MFN 06-532 Supplement 1

**Subject: Response to Portion of NRC Request for Additional Information
Letter No. 83– Related to ESBWR Design Certification
Application – RAI Number 20.0-5/S01**

RAI Numbers 20.0-5 S01

DCD Markup Pages

Figure 3.8-6. RCCV Wall High-Energy Penetration

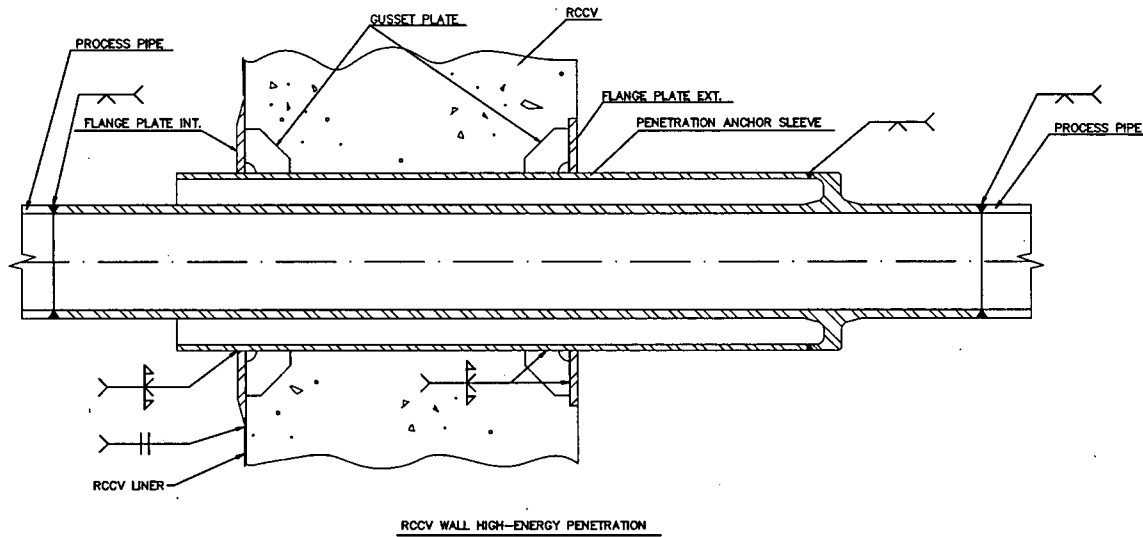
In GE's response to RAI 20.5, GE did not provide a clear response to the staff's original RAI question. It is still unclear if backing bars are going to be used on any of the containment penetration welds in the ESBWR design. In order for the staff to determine that the issues raised in BL 80-08 associated with ultrasonic testing of containment penetration welds using backing bars are addressed in the DCD, the staff requests that the applicant modify the DCD to state that weld joint designs for the ESBWR containment liner penetrations do not utilize backing bars. In addition, the staff notes that weld joint designs in DCD, Tier 2, Revision 3, Figures 3.8-7, 3.8-6, 3.8-8 3.8-9, 3.8-10 and 3.8-11, show that a square groove weld joint design will be used to join the flange plate to containment liner. The staff is concerned that the weld joint configuration shown in the aforementioned figures may not provide sound welds given that there is no required beveled edge on the weld joints and no indication that back grinding and welding will be performed. The staff requests that the applicant provide details as to how these welds will be performed (e.g. back grinding and welding or removable backing etc.) and the NDE that will be performed on these welds.

The welds between the penetration flange and containment liner shown in DCD Tier 2 Figures 3.8-6, 3.8-7, 3.8-8, 3.8-9, 3.8-10, and 3.8-11 will be revised to show that they are square groove welds welded from both sides. Square groove welds are an acceptable joint configuration per ASME Code for the thickness involved. Please note that the insert plate of the penetration sleeve is tapered to match the thickness of the liner at the weld joint. Welding procedures comply with ASME Code for cleaning out the root pass of the first weld prior to applying weld metal to the second side. NDE to be performed on the welds is shown on Table 3.8-5.
